SUBDIVISION COMMITTEE
METROPOLITAN AREA PLANNING COMMISSION

STAFF REPORT
(Final Plat) *preliminary plat*

CASE NUMBER: S/D 96-92 - PETERSON ESTATES

(Revised Preliminary Plat, Preliminary Plat Deferred 12/12/96)

VICINITY MAP:

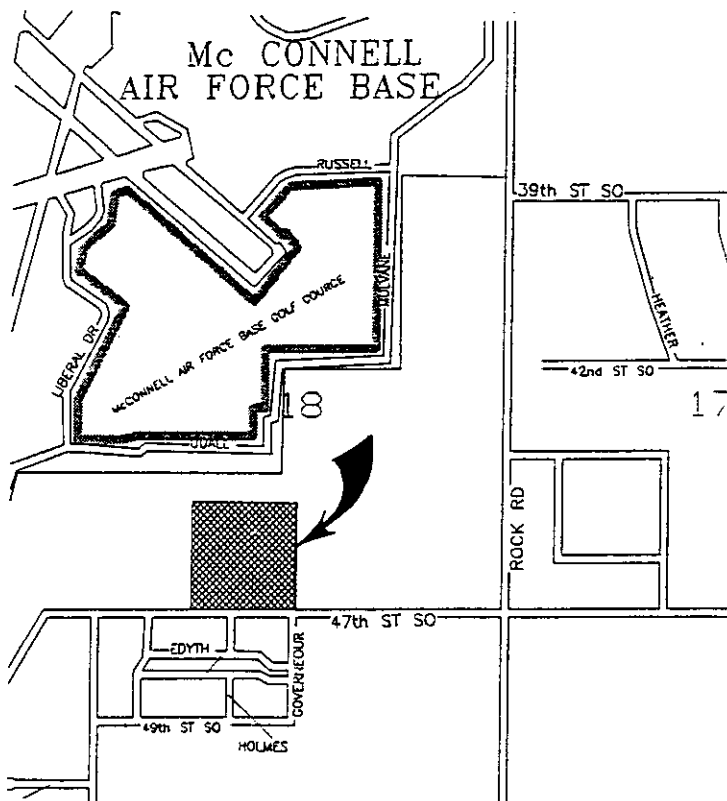
- A. It is recommended that the plat as submitted be denied and a revised plat meeting the requirements both of the Zoning Ordinance and Subdivision Regulations be submitted. This recommendation is based on the following requirements:

1. The revised zoning ordinance indicates that a lot width of at least 100 feet is to be provided from adjacent streets, at the appropriate building setback line. Lot 4 fails to meet this requirement.

2. Flag type lots are to be avoided except in the case of a unique situation or in order to allow for or encourage solar access. Lot 4 again violates these standards.

3. Access to residential lots should be provided when possible by means of interior streets with complete access control platted from lots to adjacent arterials. All four (4) lots, particularly Lots 1, 2, and 3 violate this requirement. Further, there are no apparent or overriding conditions that indicate some form of an interior street such as a short cul-de-sac couldn't be provided so as to have all lots with access by such a street rather than 47th Street South.

Based on the above considerations, a revised plat shall be submitted providing access for all lots by means of an interior street. Based upon such a revised plat, the following conditions, subject to revisions, shall apply.

- B. The applicant shall guarantee the installation of the interior street to the Suburban gravel standard. Such street shall also be platted with a 70-foot right-of-way. Complete access control shall also be indicated to 47th Street South for all adjacent lots.

VICINITY MAP:

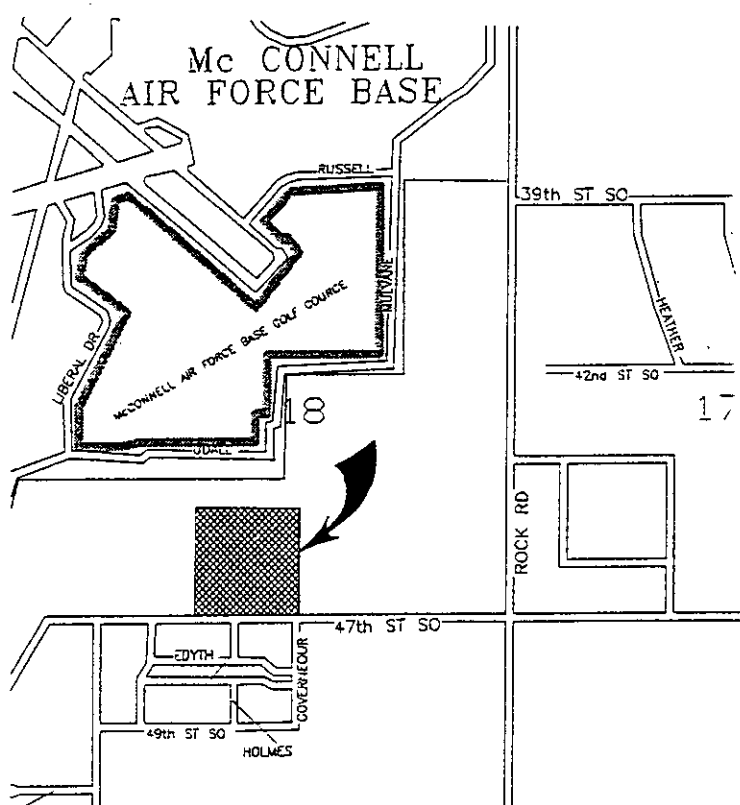
- A. The applicant shall guarantee the installation of the interior street to the Suburban gravel standard. Such street shall also be platted with a 70-foot right-of-way. Complete access control shall also be indicated to 47th Street South for all adjacent lots.

- B. The applicant shall guarantee any drainage improvements required by the platting of this property. County Engineering needs to indicate any other requirements in regard to this site's drainage such as; if a floodway or other drainage type areas need to be defined for this site (Reserves, easements, etc.), if minimum building pad elevations are required, are any off-site drainage easements involved, and so forth.

- F. The dedication of access controls shall be noted in the plattor's text on the final plat tracing. This dedication shall be to the "appropriate governing body" with the opening location for Lot 3 subject to approval by the "appropriate engineer".

- H. The platting of a Floodway Reserve shall be noted in the plattor's text. Since this plat requires the platting of a floodway, the plattor's text of the final plat shall reference the standard floodway language. Also if minimum building pad elevations are required, both on-site and off-site benchmarks shall be indicated in the final plat. Such minimum pads shall also be noted both on the face of the plat and in the plattor's text.

VICINITY MAP:

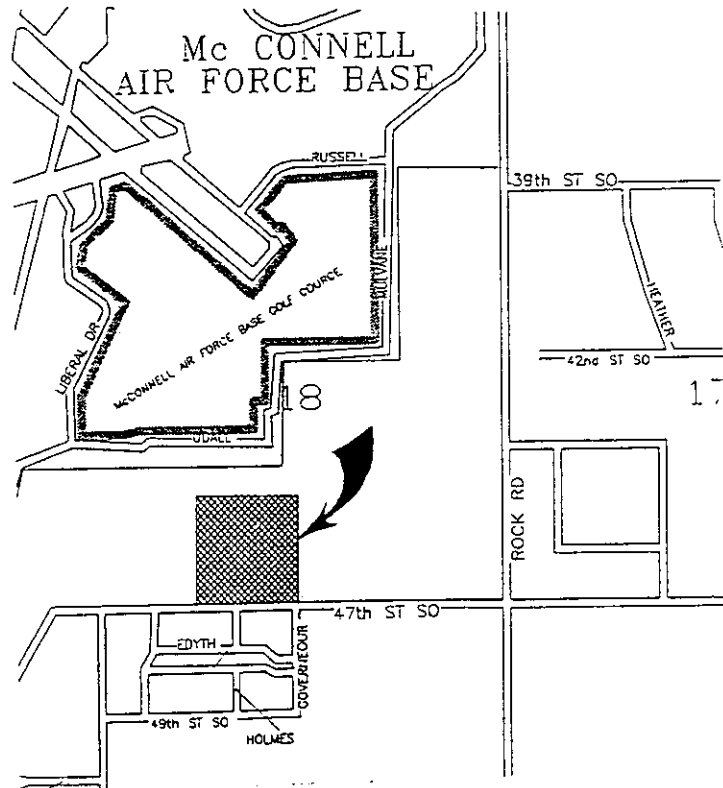
- A. The applicant shall guarantee the installation of the interior street to the Suburban gravel standard. Such street shall also be platted with a 70-foot right-of-way. Complete access control shall also be indicated to 47th Street South for all adjacent lots. Lot 3 shall indicate access control except for one (1) opening to 47th Street South. County Engineering should comment on the width of this paved street as well as the type of surface to be used.

- D. As indicated by County Engineering, dimensional information shall be provided so as to precisely describe the involved Floodway. The final plat shall also indicate a minimum building pad elevation of 1,335 ft. M.S.L. for Lots 3 and 4. Both on-site and off-site benchmarks shall also be provided.

- E. The dedication of access controls shall be noted in the platter's text on the final plat tracing. This dedication shall be to the "appropriate governing body" with the opening location for Lot 3 subject to approval by the "appropriate engineer".

- G. The platting of a Floodway Reserve shall be noted in the platter's text. Since this plat requires the platting of a floodway, the platter's text of the final plat shall reference the standard floodway language. Also if minimum building pad elevations are required, both on-site and off-site benchmarks shall be indicated in the final plat. Such minimum pads shall also be noted both on the face of the plat and in the platter's text.

- N. The final plat shall indicate the utility easements requested by K.G.& E. which are indicated on the enclosed "marked" copy of the plat.
- O. The Chair Pro-Tem signature block should be amended to read Paul W. Hancock.

- P. The City Council in the Mayor's signature block is misspelled and should be corrected before submittal of the final tracing.
- Q. In the platter's text, the "a" should be removed before "...lots, and streets."
